# Hawthorns Area of Windy Hill Preserve Public Access Working Group

## Meeting #6 – Site Meeting and Design Discussion March 2024

PAWG Meeting #6 Site Meeting and Design Discussion Materials

**Hawthorns Area Public Access Working Group**  
**Parking Options 8 and 9 Concept Design Comparison**  
*Hawthorns Area Plan*

OPTION 9 - PLAN

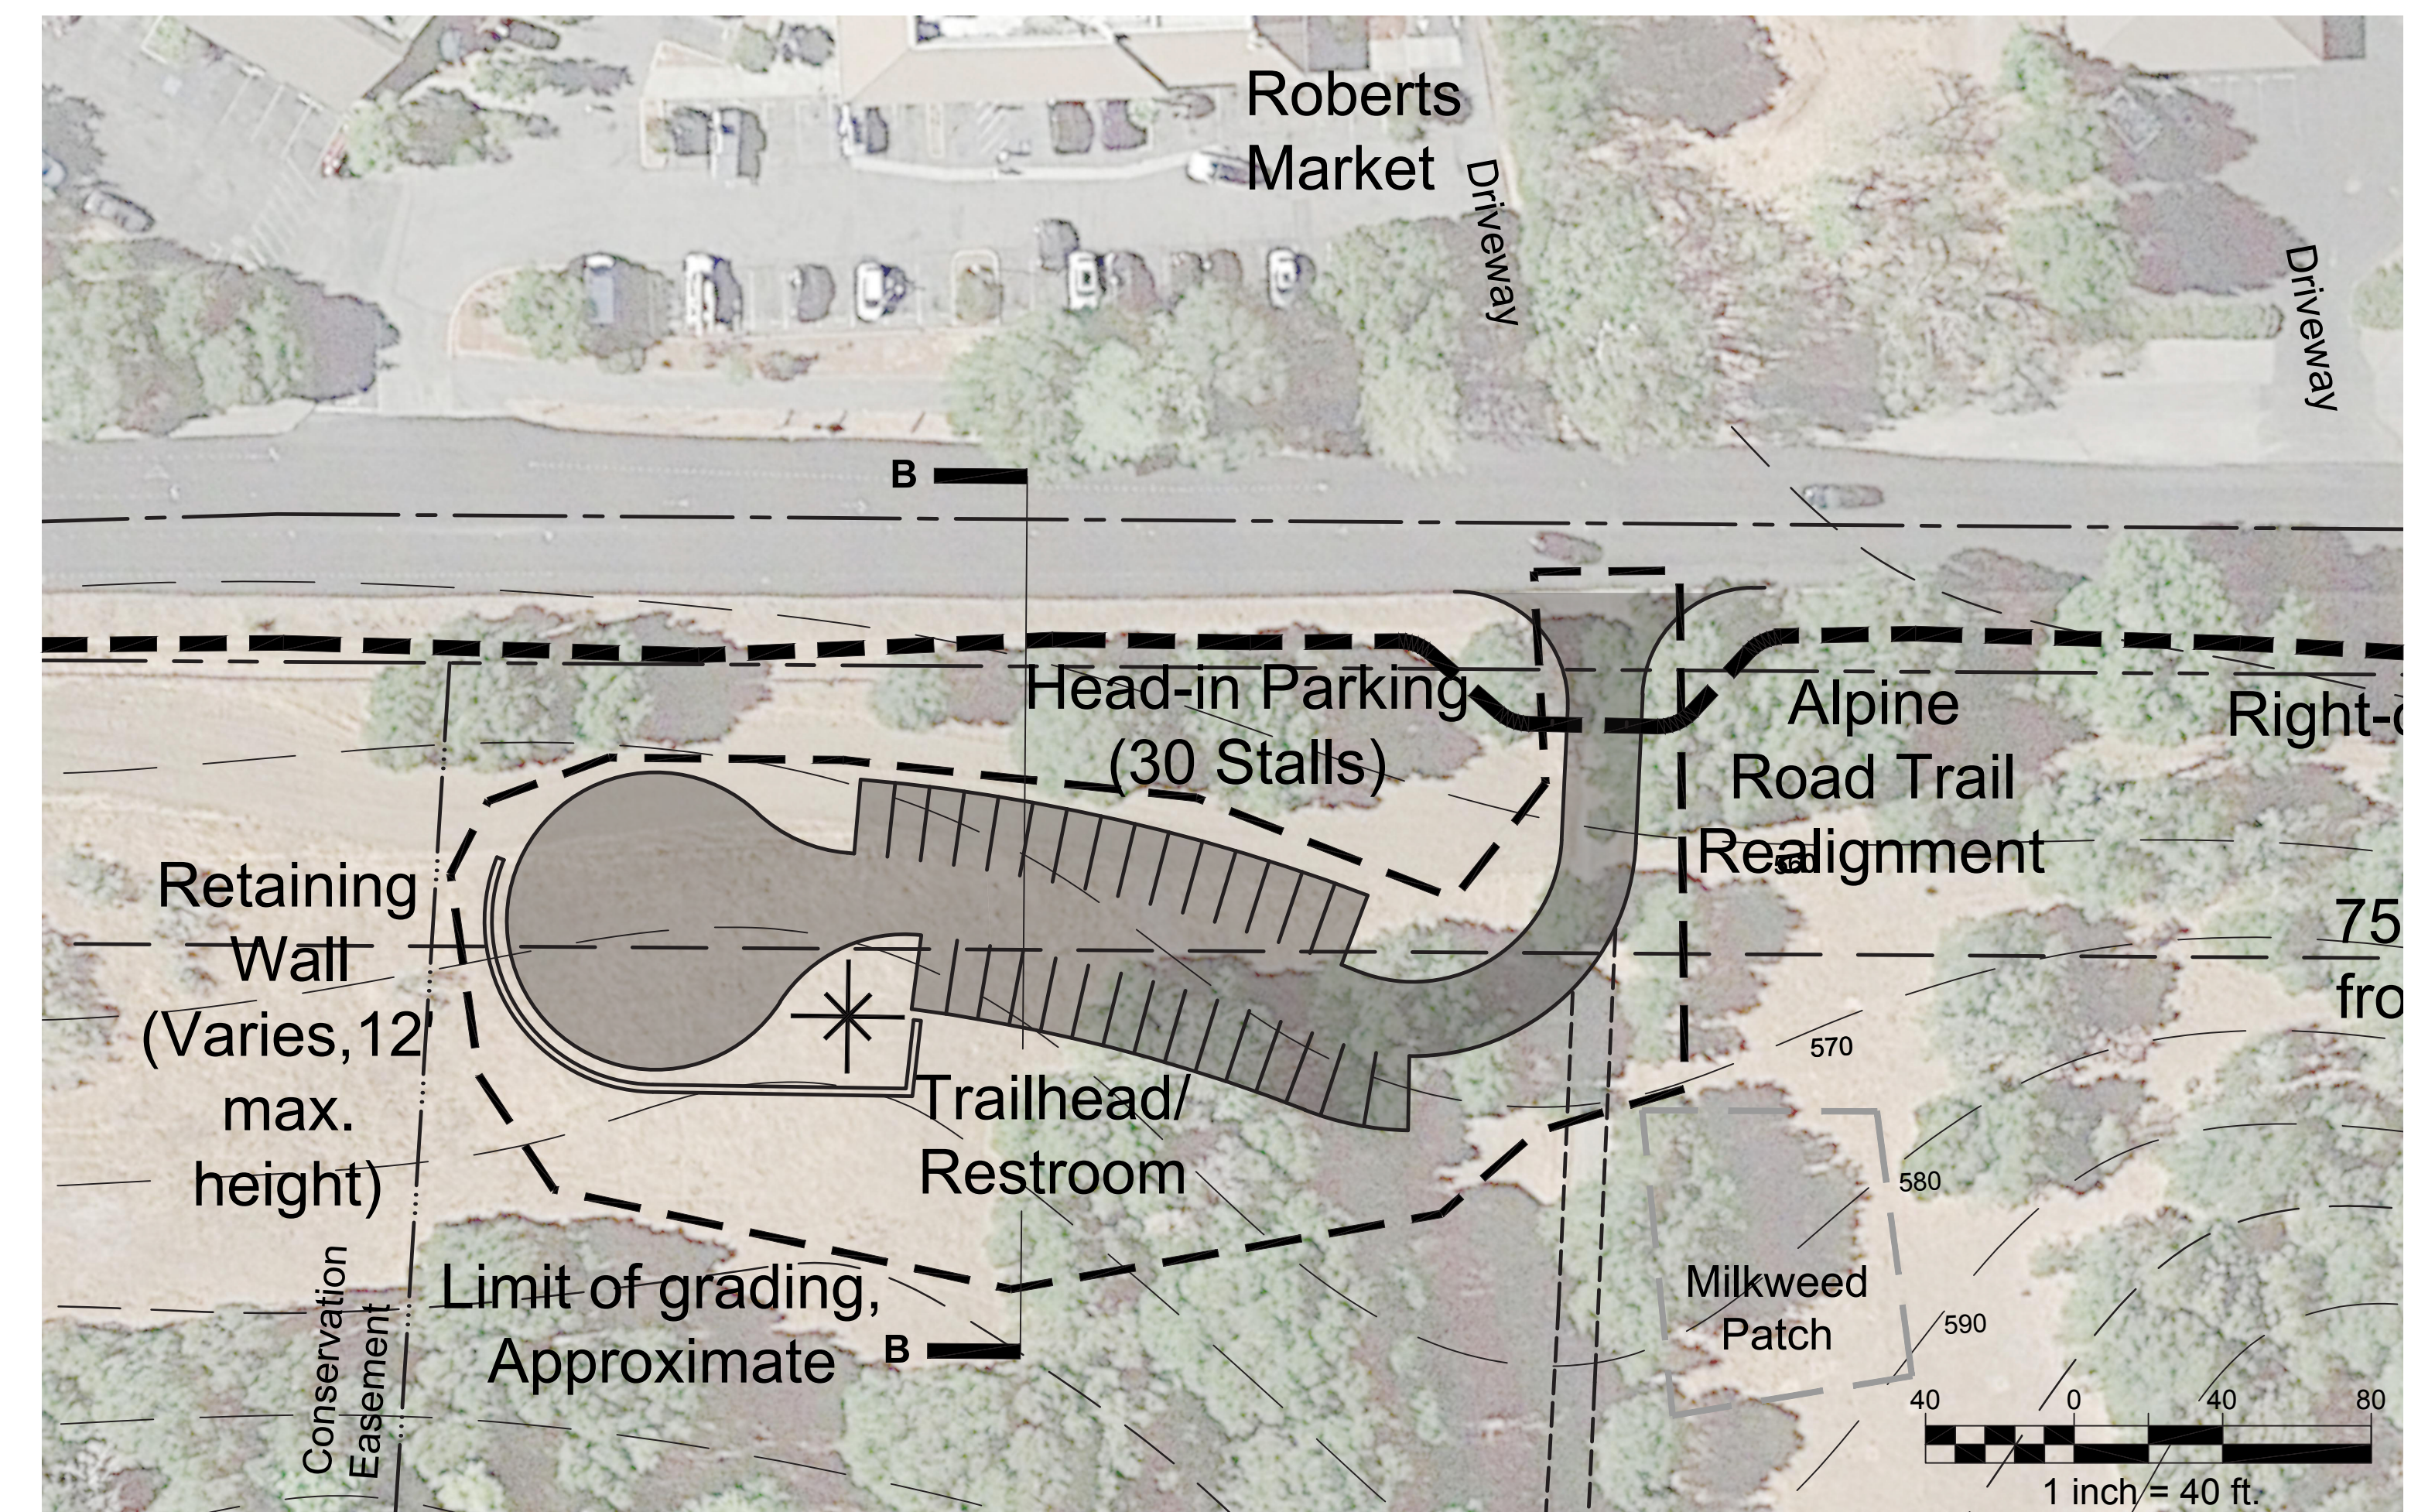
After the February 29, 2024 Public Access Working Group (PAWG) meeting, two PAWG members sent the Midpen project team a couple other parking lot options to explore. The project and consultant team looked into these ideas to assess the potential number of parking spaces the new location could accommodate and the impact on the existing site. The result is parking lot option 9, which locates a 30-space parking lot to the right of the existing driveway. During the upcoming site meeting on March 24, the project team will guide the PAWG to this location to gather their feedback on whether they would like to pursue this option further.

For the PAWG's consideration, attached is a side-by-side high level comparison of options 8 and 9. The excavation required for option 9, particularly into the hillside, will be considerably more extensive than for option 8. Both options assume a 2:1 slope for the uphill cut. While option 8's section appears similar, the cut/fill is closer to being balanced onsite due to fill at the entrance and turnaround areas. In option 9, however, all grading will involve cutting into the hillside, resulting in significant off-haul and a 12-foot-high retaining wall. The cut and fill could be balanced if two 6-foot-high walls are installed on the uphill and downhill side of the parking lot.
